Report of the Nuclear Regulatory Commission - Department of Energy
Meeting of the Geohydrology Testing Program before Construction of the
Exploratory Shaft

April 9, 1987

Written Comments by NRC on DOE Pre-ES Hydrologic Testing Program

Cement Effects

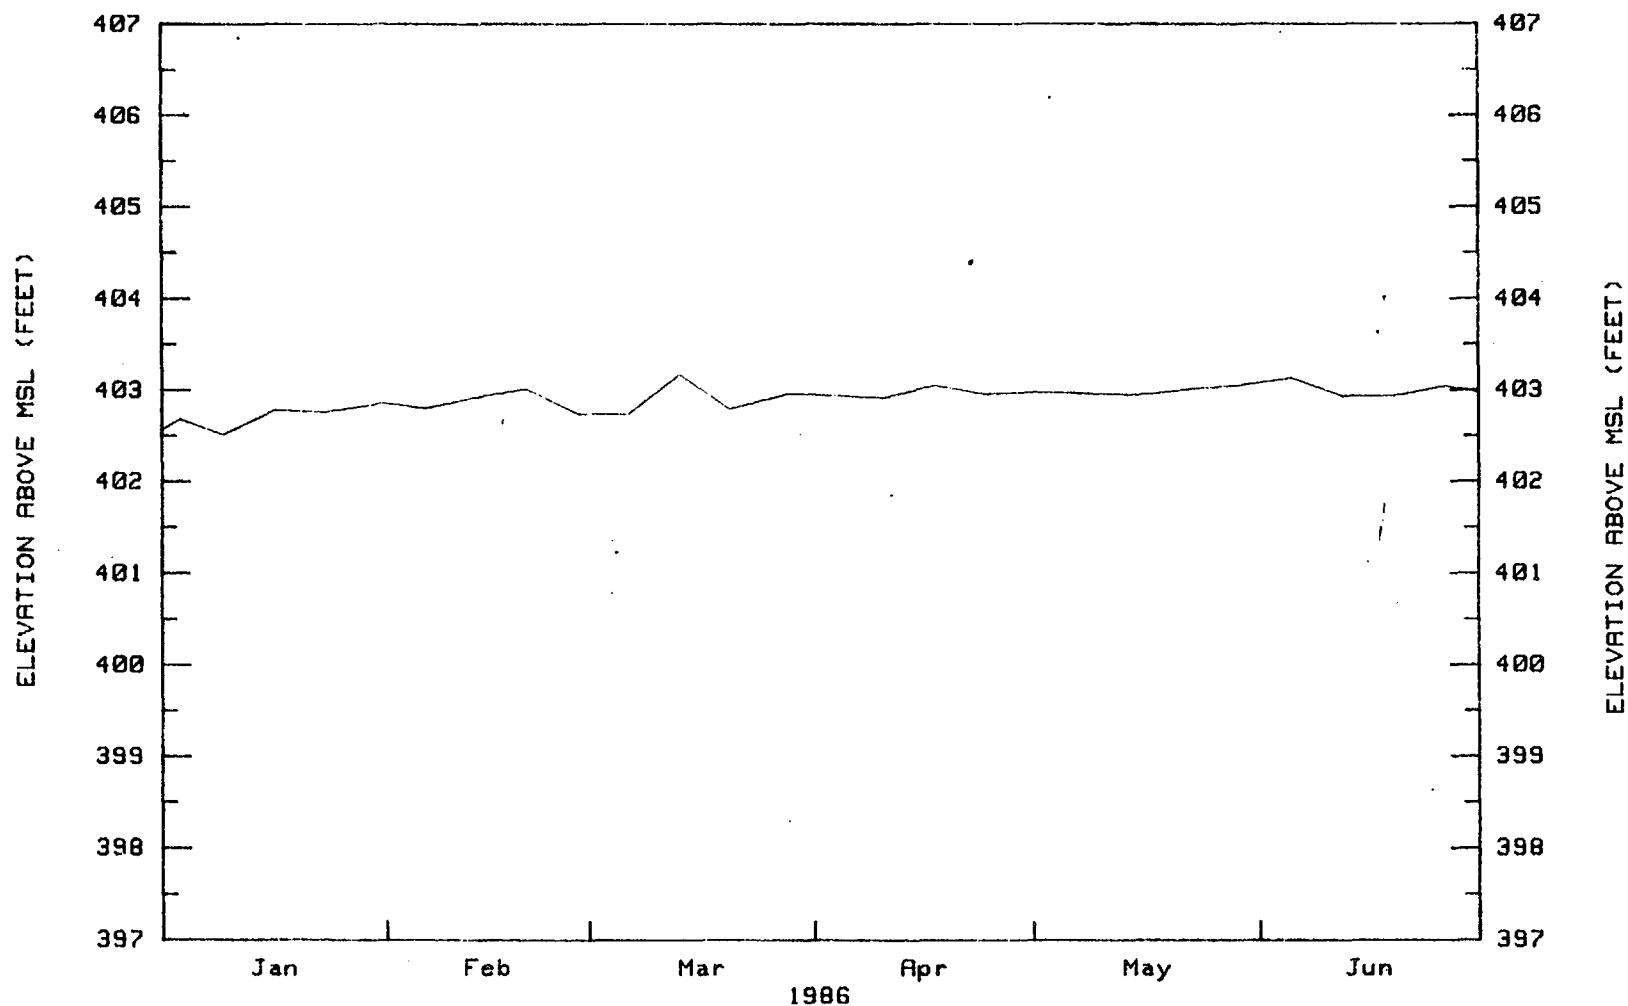
- BWIP did not Document the Basis for Concluding that Cementing of the Rocky Coulee Flow Top at RRL-2A and RRL-6 During Construction does not Significantly Inhibit Hydraulic Communication

- BWIP has Provided the Requested Documentation
- Spot Cementing of Rocky Coulee Flow Top at RRL-2A had Minimal Effect on Hydraulic Properties
 - Transmissivity Estimates for Hydraulic Test Performed Pre- and Post-Cementing are of Similar Magnitude
 - Dynamic Temperature Logs Indicate Water Production from the Rocky Coulee Flow Top
- Cementing Effects on Hydraulic Properties of the Rocky Coulee Flow Top at RRL-6 not as Well Known
 - Time-Series Water-Level Data from Subsequent Monitoring are Consistent with Data from Other Rocky Coulee Flow Top Observation Points
 - Addition of Monitoring at DC-32 Makes Measurements at RRL-6 Less Critical

Pump Selection

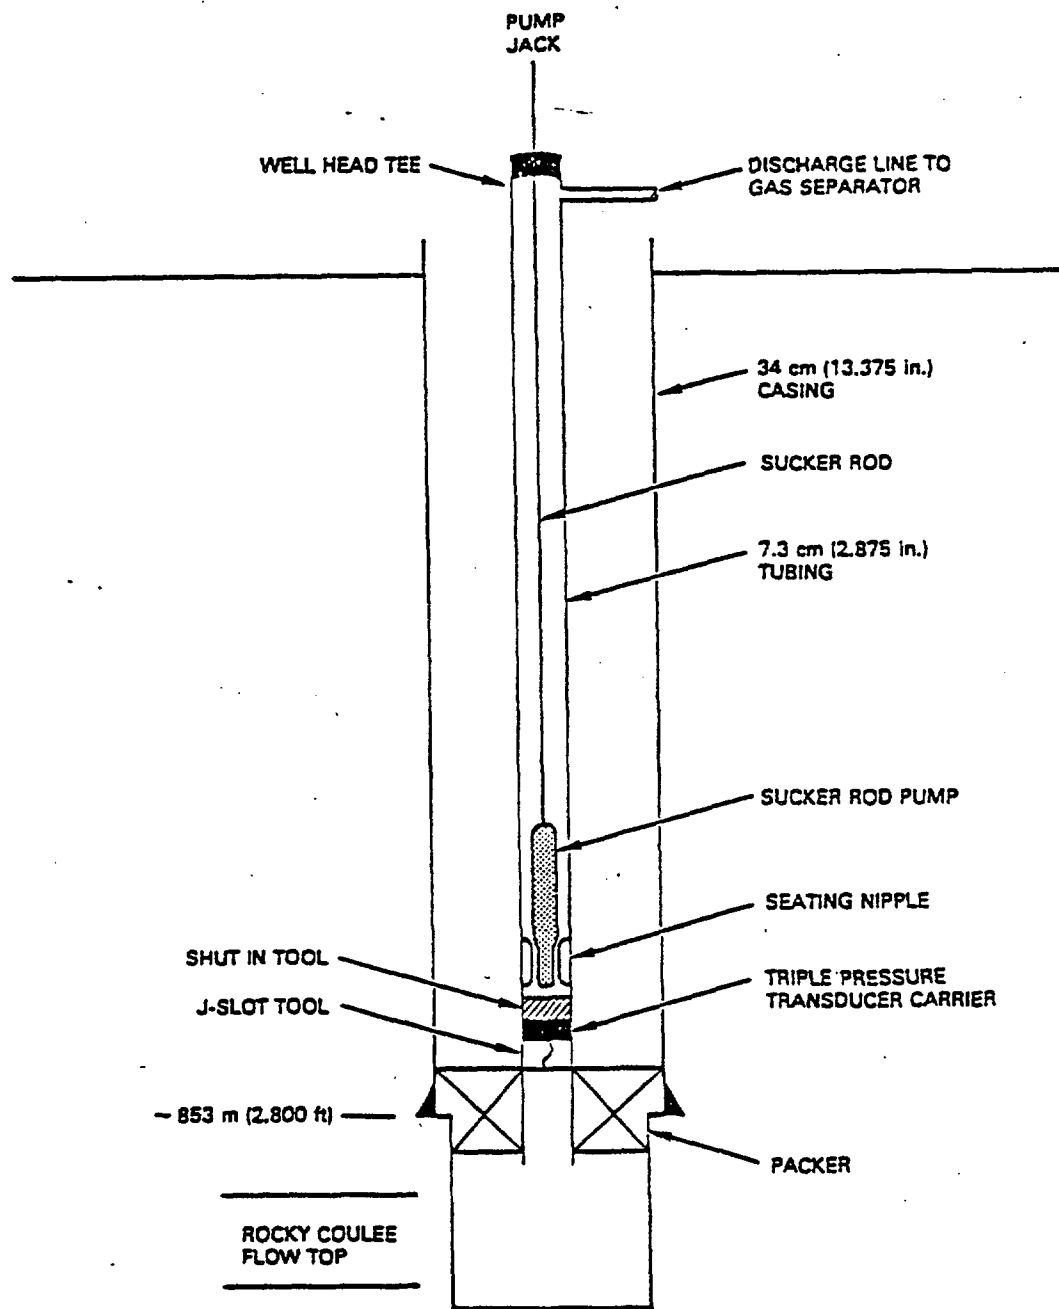
- Pressure Fluctuations in the Pumping Well and Nearby Observation Wells RRL-2C and RRL-2A Complicate Test Interpretation
- Changes in Pumping Rate are Difficult to Accomplish

- Hydraulic Head Fluctuation at Nearby Observation Points is not Expected to have an Adverse Effect on the Interpretation of the Test
- Data from the Pumping Well During the Drawdown Part of the Test is not Regarded as Particularly Useful Because of Frictional Losses Near the Well Bore
- Use of the Positive Displacement Pumping System is Expected to Mitigate Problems such as Gas Lock Associated with Submersible Centrifugal Pumping Systems
- Test must be Stopped to Change Discharge Rate
- Dry Run Checks will Afford Opportunity to Check Pump Operation Prior to LHS Test
